Recall Campaign Bulletin

Campaign No. 2015020003, February 2015

SUBJECT: Model 205 (C-Class), Model Year 2015 Retrofit Headlamp Adjustment Screw Caps

Figure 1

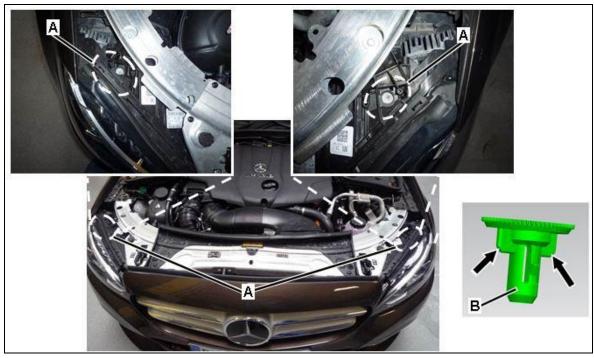
Daimler AG (DAG), the manufacturer of Mercedes-Benz vehicles, has determined that the headlamps might not meet the requirements of Federal Motor Vehicle Safety Standard (FMVSS) 108, which requires that headlamps with low beams must not have a horizontal adjustment mechanism. The subject vehicles are designed to meet this requirement by sealing off the headlamp horizontal adjustment screw with a non-removable sealing cap after initial adjustment in the manufacturing plant. The sealing cap may not have been installed on these vehicles. An authorized Mercedes-Benz dealer will retrofit the two sealing caps. This recall affects dealer inventory only. Affected vehicles must be repaired prior to sale or lease.

- 1. Open hood.
- 2. Retrofit cap (B, Figure 1) for headlamp adjustment screws (A) at left and right:
- Position cap (B, Figure 1) on headlamp adjuster (A) so that the tabs (arrows) on the cap (B) align with the grooves in the adjuster (A).
 - Press the cap (B) into adjuster (A) by hand until it locks into position.

An audible click will be heard when the cap (B) is properly seated into the adjuster (A).
